# FLORIDA POWER & LIGHT COMPANY

#### ST. LUCIE PLANT UNIT NO. 1

#### AMENDMENT TO FACILITY OPERATING LICENSE

Amendment No. 81 License No. DPR-67

- FIGURE 3.4-3

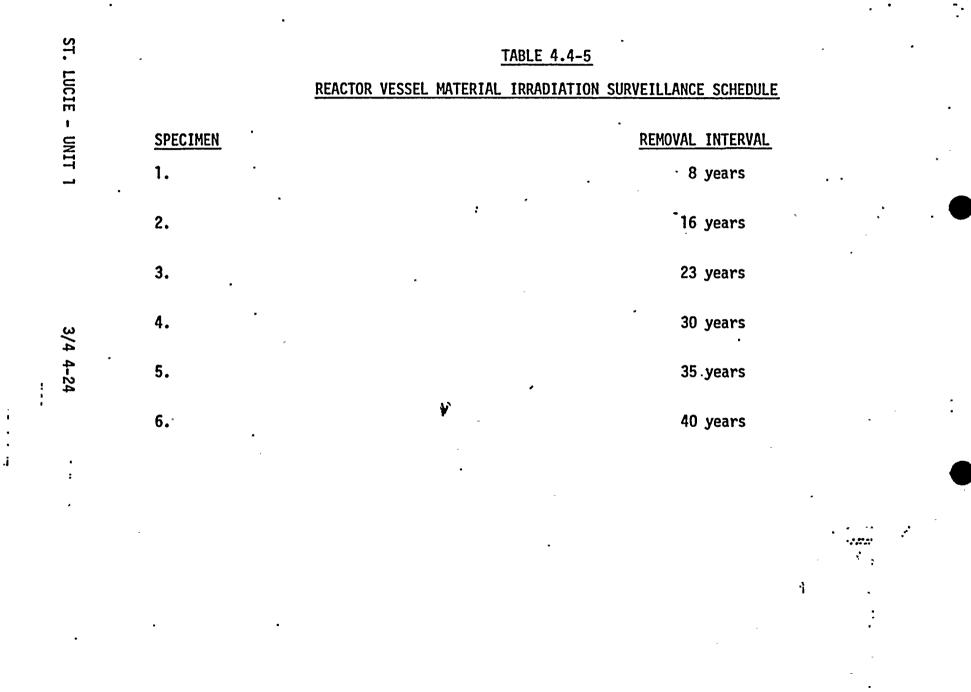
NOTE: A MAXIMUM COOLDOWN RATE OF 100°F/HR IS ALLOWED AT ANY **TEMPERATURE ABOVE 175°F**
